# Beckfoot Allerton School - Accessibility Action Plan.

Updated: 10/01/2025

Figure 40 — *Unisex accessible toilet with carrier WC layout where other accessible toilet accommodation is available*

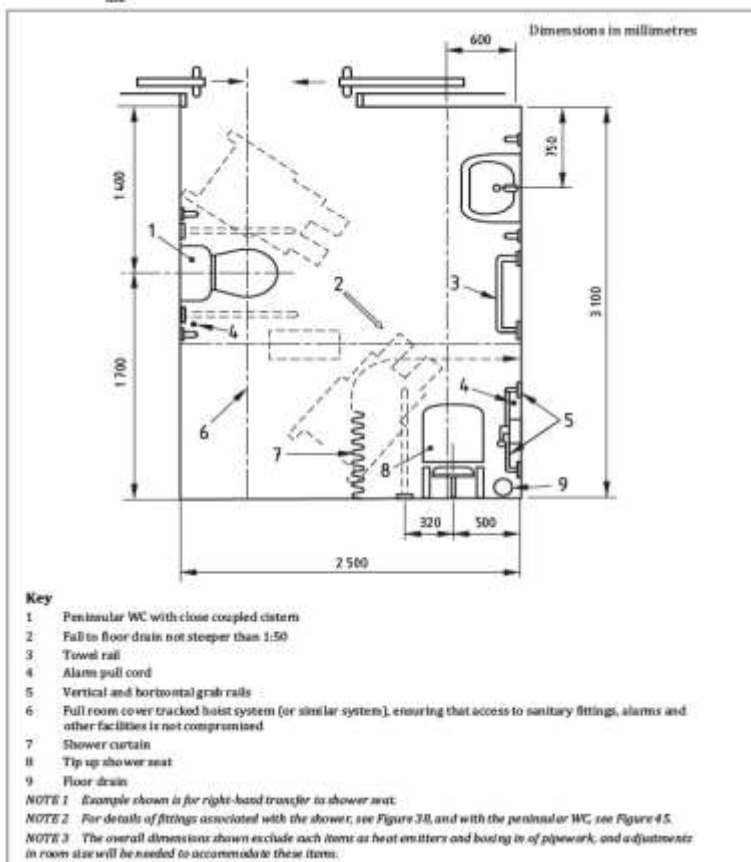
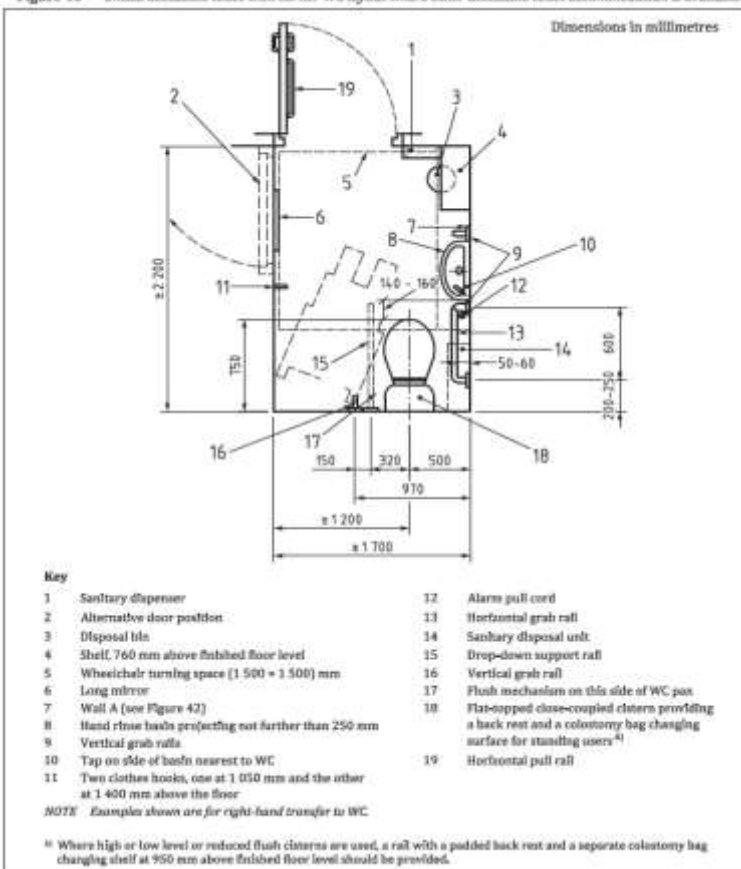
13.7	<p>WC 57 was missing the horizontal and drop down grab rails to the right of the WC pan. Some are located near to the shower and obstructed by the shower curtain and don't seem part of the WC fittings. Grab rails did contrast however.</p> <p>WC 37 is not currently used as an accessible WC, being used as the girls changing area for the Nursery. It still has the signage however. it does not have the required grab rails if it were to be used as an accessible WC in future.</p>	<p>A full BS8300 compliant set of grab rails should be provided where required, appropriate to the layout of the WC provided. Refer to the images below for locations of the required grab rails.</p> <p>Ensure any installed fixtures and fittings contrast from the surrounding surfaces.</p>	<b>M/OG</b>	
------	---	---	-------------	--

**Diagram 3 Relationship of ramp gradient to the going of a flight**

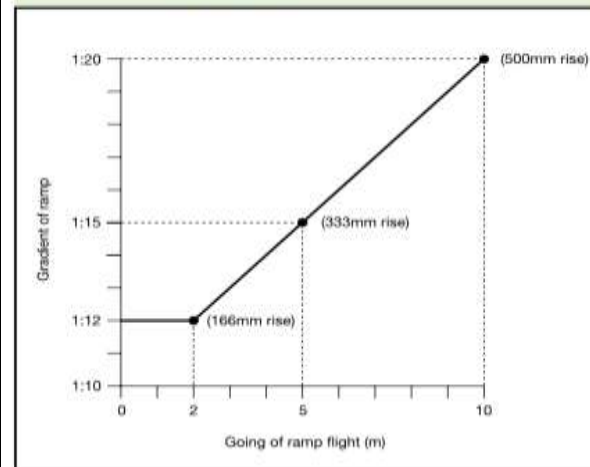
The older ramps seen do not have colour contrast to the surface to indicate the presence of a gradient. Some are also steeper than recommended.

Ramp at Main Entrance - not used as obstructed by flowerpots at top?

Gradient 10 degrees/ 1:5.671

Entrance to Nursery area 32 gradient 9 degrees / 1:6.314

ADM require ramp gradients to be within 1:20 - 1:12. Dependent on heritage requirements, surfaces need to be slip-resistant especially when wet and of a colour that contrasts visually with that of the landings.

Some of the current access route ramps are of a gradient steeper than that deemed reasonable under ADM. Where possible, during any future works, the gradients of these primary access routes should be reduced to provide an ADM compliant ramp gradient as below:

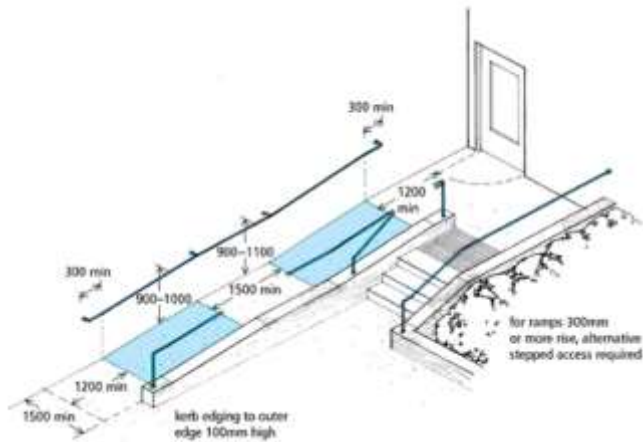
Most ramps had handrails provided on one side.

Some ramps had black handrails which did not contrast where the walls were darker.

Handrails are a relatively simple and cost-effective adjustment that provides a range of benefits; support, guidance, guarding and route definition. All of these features improve accessibility for disabled people. Implement a rolling programme to upgrade handrails to achieve AD M and BS8300 compliance. Ramps serving communal facilities and access routes used by disabled people should be prioritised with others included as part of any refurbishment or alteration works in future.

ADM vol-2 requires handrails on both sides. BS8300 compliant handrails should be installed to both sides of a ramp. The handrails should be coated with nylon or a suitable alternative to ensure that they are not cold to touch. The handrails should provide the required 300mm horizontal landing extensions with the entire handrail located at a height of 900-1000mm from the slope and landing surface as required by BS8300 and ADM vol-2.

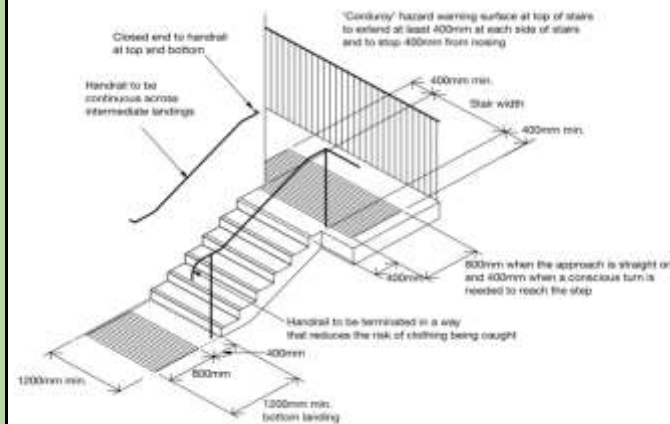
The following external steps do not feature tactile paving to assist people with impaired vision.

Main Entrance Steps

Entrance area 56

Tactile paving is an important hazard indicator for blind and partially sighted people and is expected to be present. Implement a rolling programme to install tactile hazard warning paving to the top and bottom of steps where two or more steps are present. Steps serving communal facilities and access routes used by disabled people should be prioritised with others included as part of any refurbishment or alteration works in future. ADM vol-2 requires a corduroy hazard warning surface provided at the top and bottom of each flight of 800mm x 1200mm minimum, 400mm from the step.

BS8300 - To give advance warning of a step, tactile paving with a corduroy hazard warning surface should be provided at the top and bottom of each flight, excluding intermediate landings with continuous handrails. Where the approach to the stair is wider than the flight, the tactile surface should extend beyond the line of each edge of the flight.

Figure 50 — Work surfaces and accessories

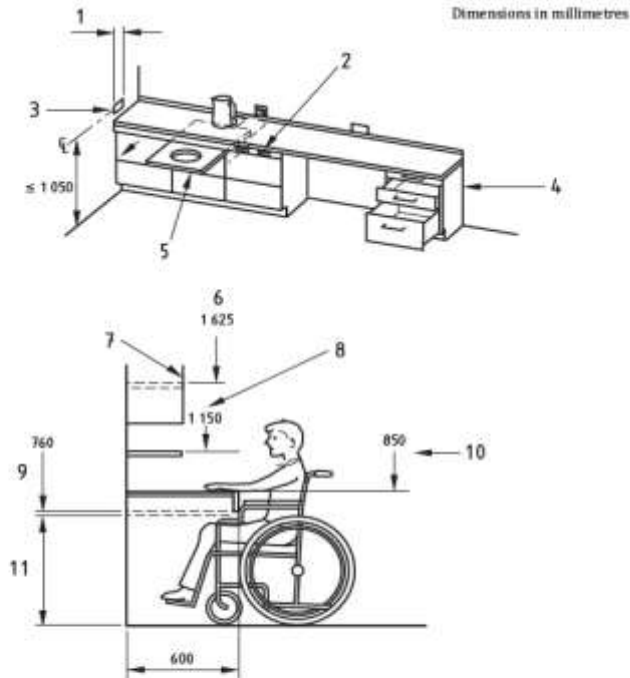
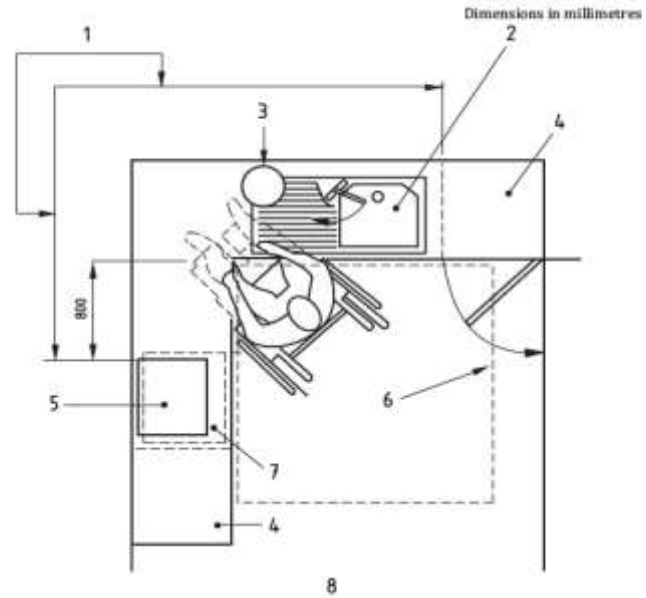
<p>14.8</p>	<p>Staff kitchenettes in rooms 9, 34 No lever taps are provided.</p> <p>Main staff room 77 has lever taps.</p> <p>No lowered counters are provided.</p> <p>EYFS classroom area has lowered counters with lever taps provided.</p>	<p>A kitchen area should have an unobstructed floor space of at least 1 500 mm × 1 500 mm between facing floor units or between floor units and a wall. Where possible, an unobstructed space or knee recess, at least 800 mm wide, should be provided to one side of kitchen appliances such as refrigerators, washing machines, freezers or ovens.</p> <p>Taps should be changed to lever style or automatic sensor taps to aid people with limited dexterity.</p> <p>The kitchenettes should include disability access, i.e., a section of work top lowered to 760mm (or 850 for a shared worksurface) with clear space underneath of minimum 700mm to allow wheelchair access; sink unit to have lever taps fitted, and utensils included.</p> <p>Refer to images.</p>	<p><b>M/ST</b></p>
